APPLICATION NO.	FILING DATE	FIRST NAMED INVENTOR	ATTORNEY DOCKET NO.	CONFIRMATION NO.
10/562,688	06/05/2006	Bernhard Plattner	1085-0001WOUS	3790
49698 7590 02/09/2009 MICHAUD-DUFFY GROUP LLP 306 INDUSTRIAL PARK ROAD SUITE 206 MIDDLETOWN, CT 06457				
EXAMINER WRIGHT, MADISON L				
ART UNIT		PAPER NUMBER		
3781				
MAIL DATE		DELIVERY MODE		
02/09/2009		PAPER

### Office Action Summary

**FIGURE 5A**

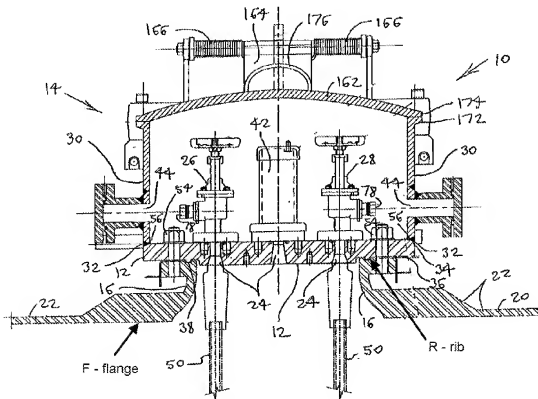
This figure used for the rejection of claims 1-4 has been replicated below, and the Examiner has added reference letters for ease of explanation, and said reference letters will be used for the rejection of claims 1-4 below.

As to claim 1, Caparros discloses a compressed gas container comprising an annular block flange that is provided on an upper opening in its wall and is welded to the container, with a flange cover equipped with at least one discharge valve being bolt connectible or bolt connected to said block flange, characterized in that the block flange (perimeter wall 16) is extended radially outside of a region coverable or covered by the flange cover (valve mounting plate 12) by a solid annular flange (part below 16 labeled F, see Figure 5A above) having its outside welded to the wall (integrally attached with primary container wall 22) of the

container (primary container 20) and having on its inside, adjacent to the coverable or covered region in an upper end face a peripheral groove (side wall groove 38) for receiving a sealing rib (R, Figure 5A) of an emergency cap (secondary containment cap apparatus 10) but does not teach that is screw connectible or screw connected to the annular flange and is used only when required, if a leak has occurred.

As to claim 2, Caparros discloses the compressed gas container according to claim 1, characterized in that the annular flange (part below 16 labeled F, see Figure 5A above) and the block flange (perimeter wall 16) are constructed as a single-piece component (Figure 5).

As to claim 4, Caparros discloses the compressed gas container according to any one of the claims 1 to 3, characterized in that the annular flange (part below 16 labeled F, see Figure 5A above) is provided with a ring of tapped bores (bolts 54) for bolting to a mounting flange (valve mounting plate 12) of the emergency cap (secondary containment cap apparatus 10).
